Addendum

SPRINGS AT FREMAUX TOWN CENTER
SLIDELL, LA

FIRST FLOOR PLUMBING PLAN - CLUBHOUSE

P1.C.11

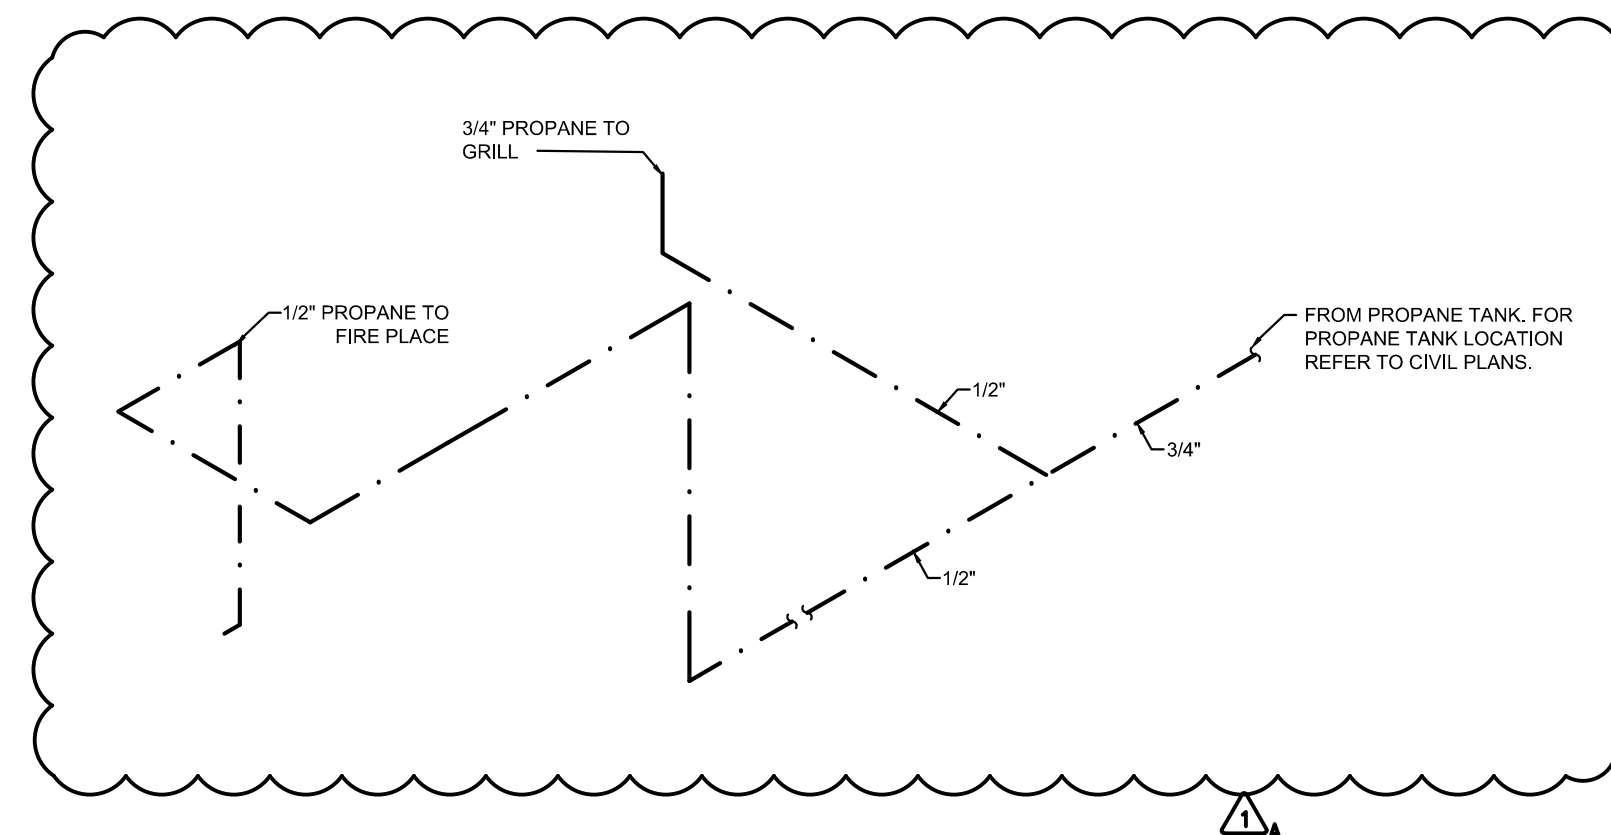
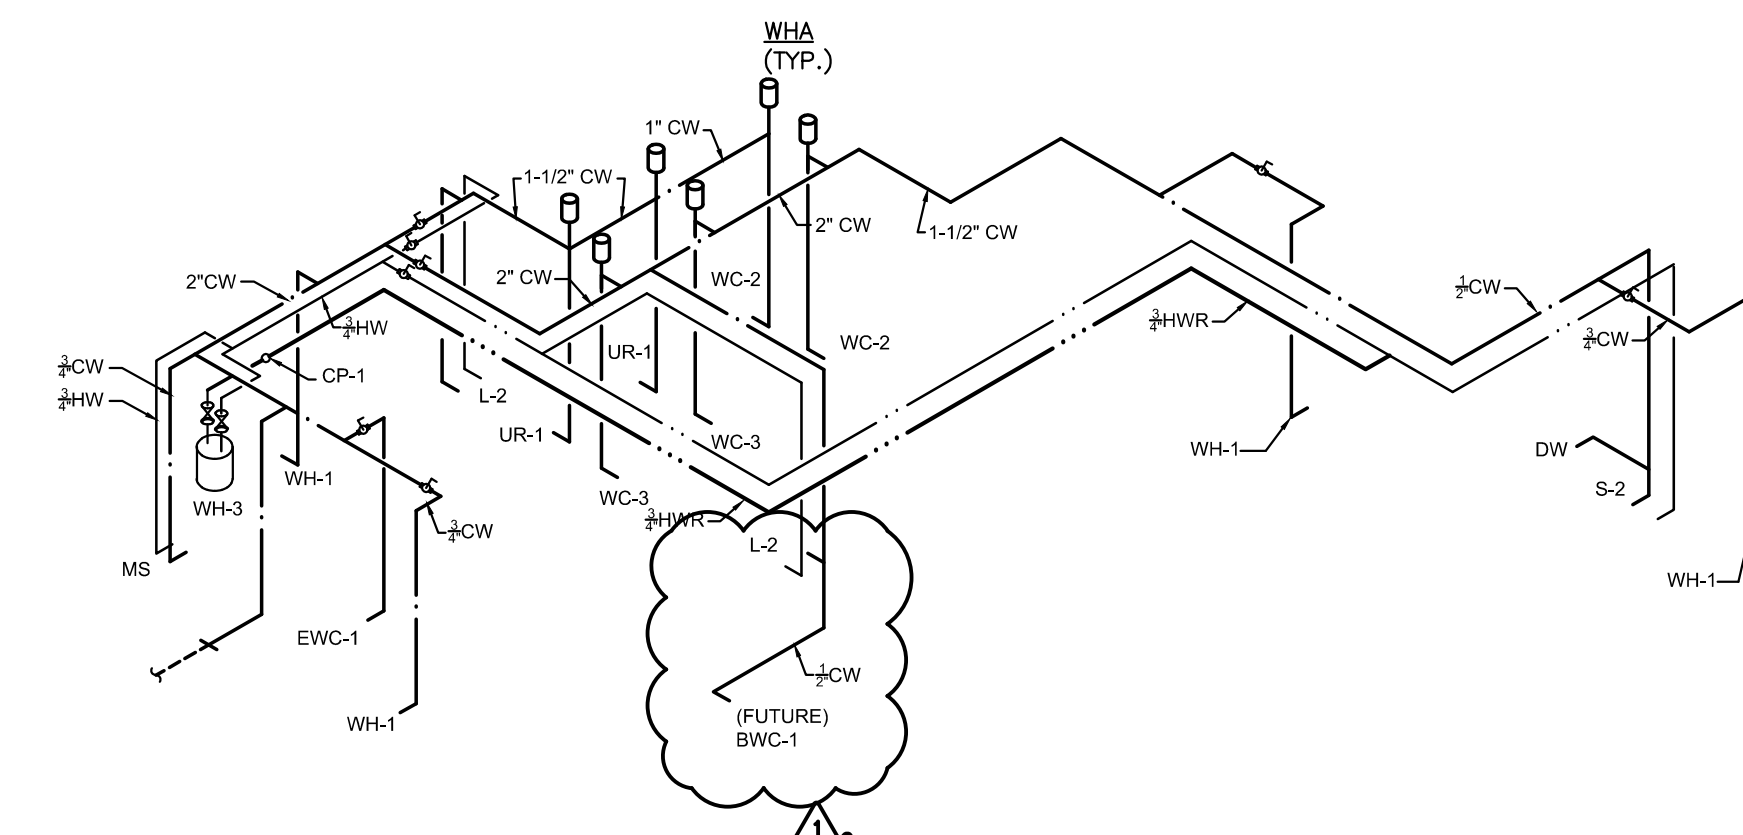
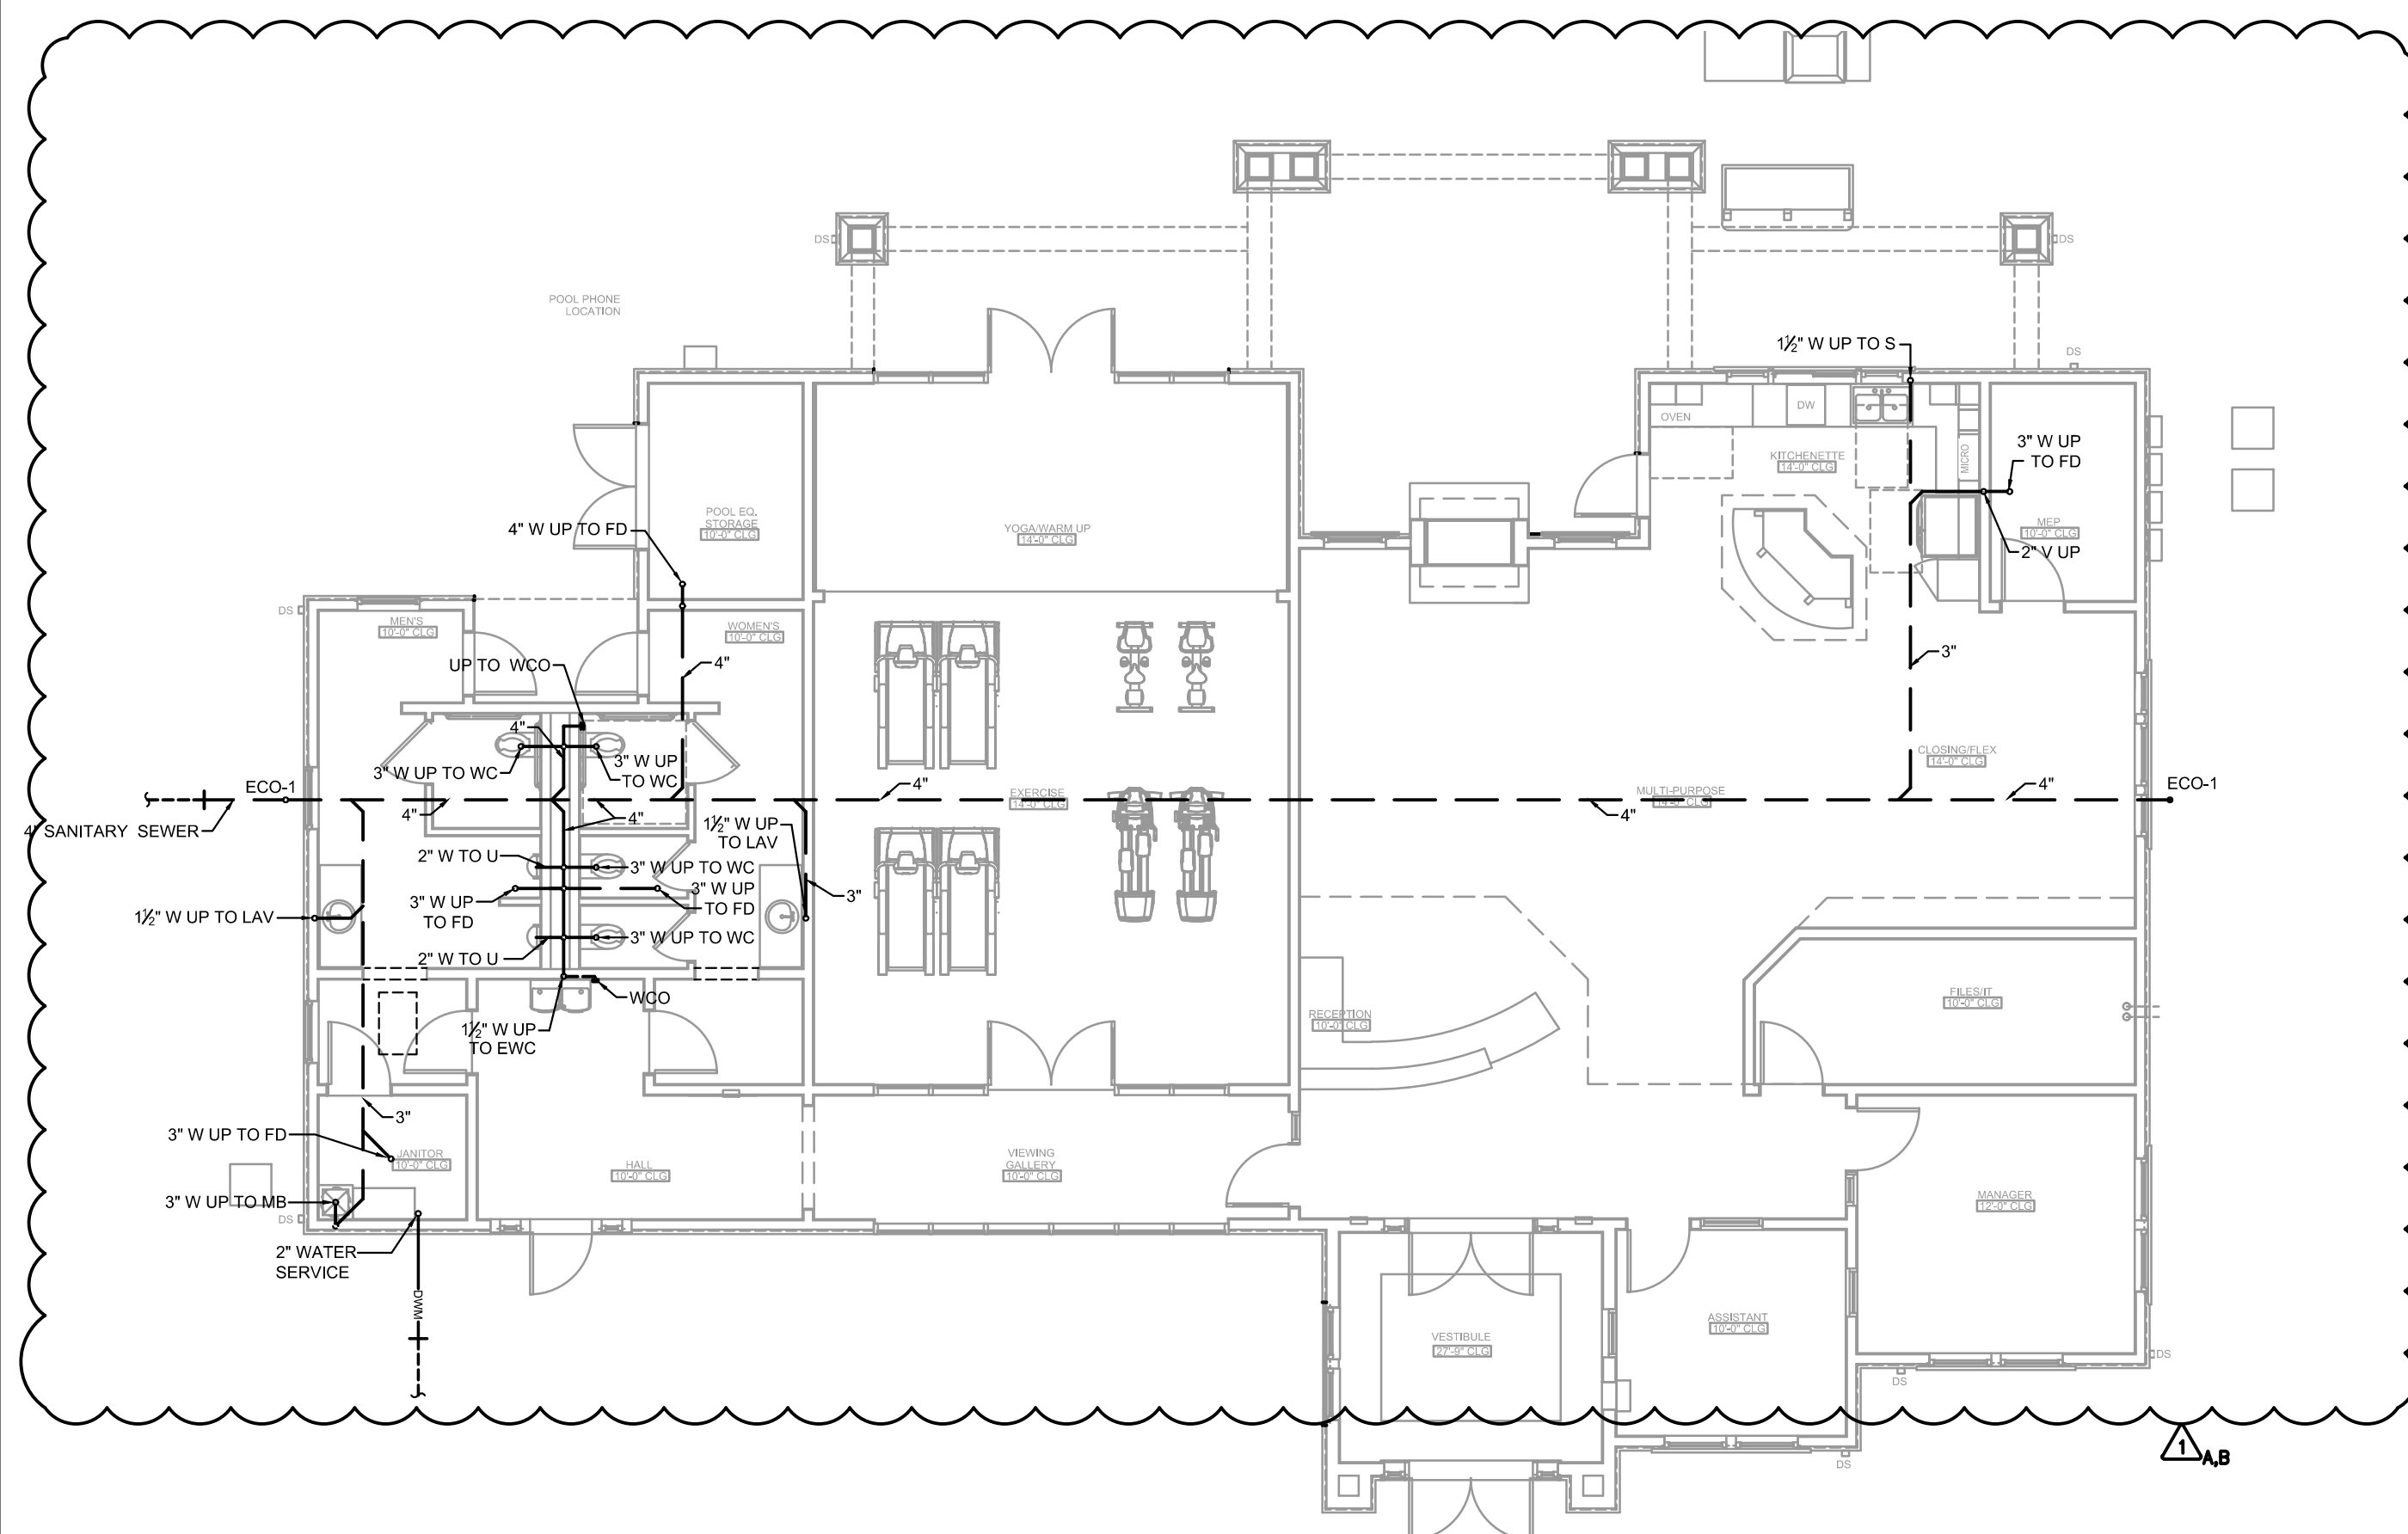
- A. REVISED GAS LINES FOR PROPANE
- B. REVISED PLUMBING PER REVISED BASE PLAN
- C. ADDED WATER LINE FOR FUTURE BOTTLELESS WATER COOLER
